REVISED RESPONSE TO REQUEST FOR ADDITIONAL INFORMATION

APR1400 Design Certification

Docket No. 52-046

RAI No.: 407-8447
SRP Section: 19.03 – Beyond Design Basis External Event
Application Section: 19.03
Date of RAI Issue: 02/17/2016

Figure 1 Locations for SFP FLEX pump connection

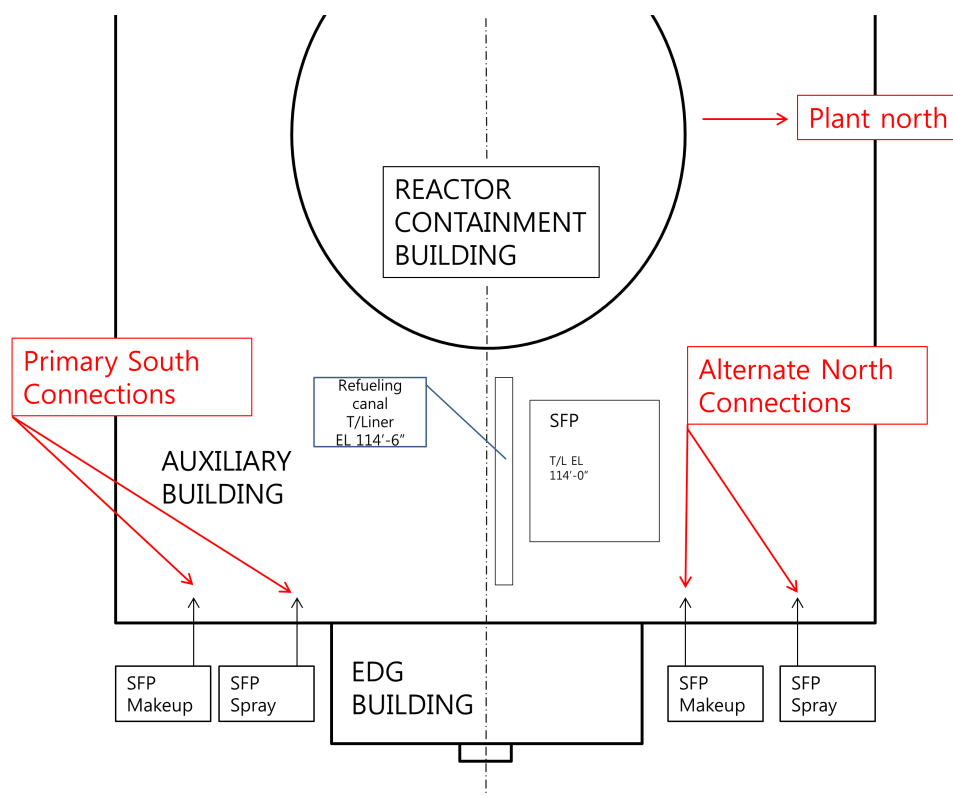
The applicant is requested to clarify how the APR1400 design for connections to the FLEX equipment is consistent with the NEI guidance.

The APR1400 mitigation strategy for SFP cooling is schematically illustrated in Figures 6-2 and 6-3, and the approximate locations for makeup water connections are indicated in Figure 6-4. The APR1400 design provides two locations for SFP makeup water connections: a set of two primary connections (one for makeup and one for spray) is mounted on the outside wall of the Auxiliary Building (AB), adjacent to the south side of the Emergency Diesel Generator (EDG) building; and the alternate set of identical connections (one for makeup and one for spray) is mounted on the outside wall of AB, adjacent to the north side of the EDG building. Please refer to Figure 1 below for illustration.

Since the external hazards (e.g., seismic events, floods, high winds, and associated missiles) are dependent on the site-specific characteristics, the protection design for applicable hazards should be the COL applicant's responsibility. Therefore, new COL item (COL19.3(16)) for the protection of the connections for FLEX strategies from external hazards will be added to DCD Tier 2 Subsection 19.3.2.3.4 and Technical Report APR1400-E-P-NR-14005-P/NP Section 6.2.11, respectively, as indicated in the attachment. In addition, a list of connections for the FLEX strategies (Table 6-5) will be added to Technical Report APR1400-E-P-NR-14005-P/NP as also indicated in the Attachment.
